Delegated Report

Householder Planning Application

Planning Application No: 20211260

Location: Downend Norwood Lane Meopham Gravesend

The proposed fenestration is as follows:

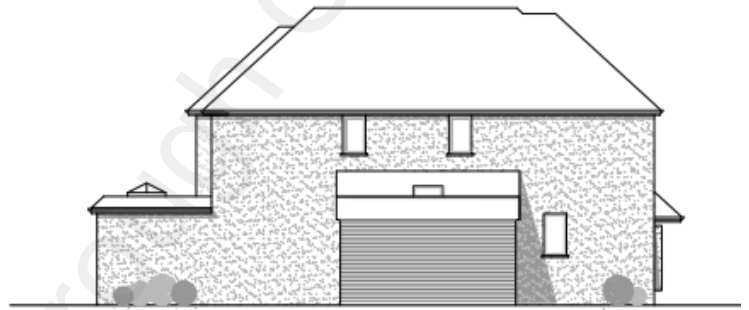
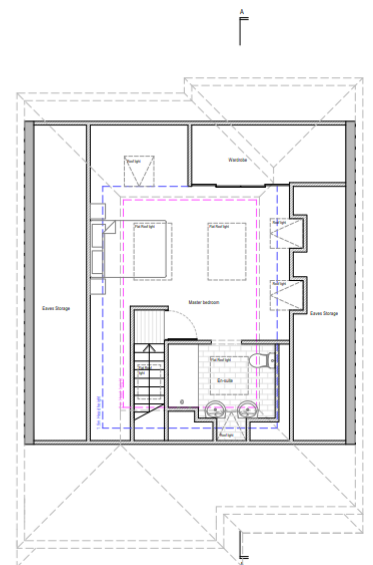
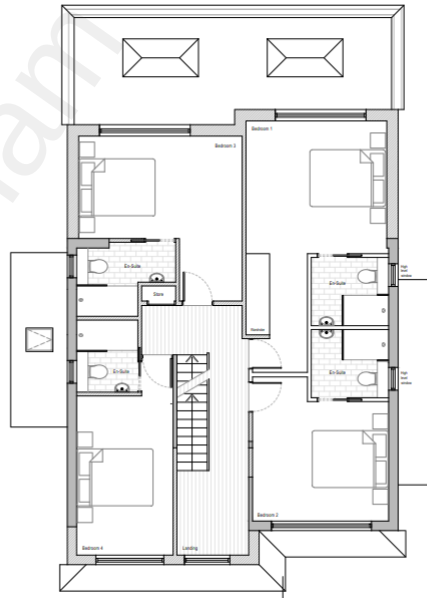
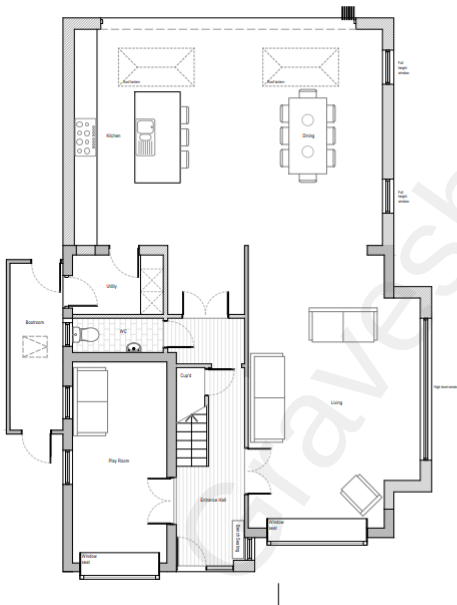
The changes are as follows:

Front north elevation

- Alter existing first floor landing window to a larger opening;
- Installation of rooflight

West flank elevation (facing Elmo)

- Installation of a new window to serve an en-suite
- Installation of two rooflights to serve a bedroom

East flank elevation (facing The Beild)

- Amendment to approved first floor en-suite window to create two separate windows to each serve en-suites.

Rear south elevation

- Installation of new rooflight

The alteration on the front elevation from the existing window to a larger glazed area involves an elongated style, a proportion that is not akin to the age or style of property but given that it would line through with the proportions of the door opening at ground floor below, that there are a variety of styles of architecture in Norwood Lane and the property is not or within a designated heritage asset, it is considered that this change to the window proportions and design is acceptable.

The new larger landing window and new rooflight to serve en-suite proposed in the front elevation would raise no issues concerning overlooking to the properties opposite which are approx. 34m away at their nearest point which exceeds the minimum SPG2 standard of 21m and the rooms are non-habitable in any case.

The rooflight in the rear roofslope would cause no overlooking given the nature of it being a rooflight and therefore giving views upwards as opposed to more open views from a window.

In the east flank elevation an en-suite window has been approved at first floor level, it is now proposed to install two smaller windows spaced further apart. The neighbouring property to the east is The Beild which has a dining room window, kitchen door and toilet window in its west flank elevation. The installation of two separate windows set further apart instead of one window to serve the en-suites is not considered to raise any increased overlooking issues over and above the approved single window. The en-suite is a non-habitable room in any case.

In the west elevation there is already a first floor en-suite window approved and it is proposed to add a second window to serve an en-suite. There are no windows in the flank elevation of the neighbouring property to the west, Elmo'. There is considered to be no increased overlooking over and above the approved single window, the en-suite is a non-habitable room in any case. The two rooflights proposed in

the west roof slope would serve a bedroom but given their nature they would have views upwards as opposed to more open views from a window and therefore there would be no overlooking to Elmo which does not have any windows in its flank elevation in any case.

Overall therefore it is considered the revised fenestration would cause no impact on amenity of any neighbouring properties.

Overall, the proposal to vary condition 3 to allow amendments to the fenestration of the development approved would be acceptable in relation to design, character and appearance and the amenity of neighbouring properties and occupiers.
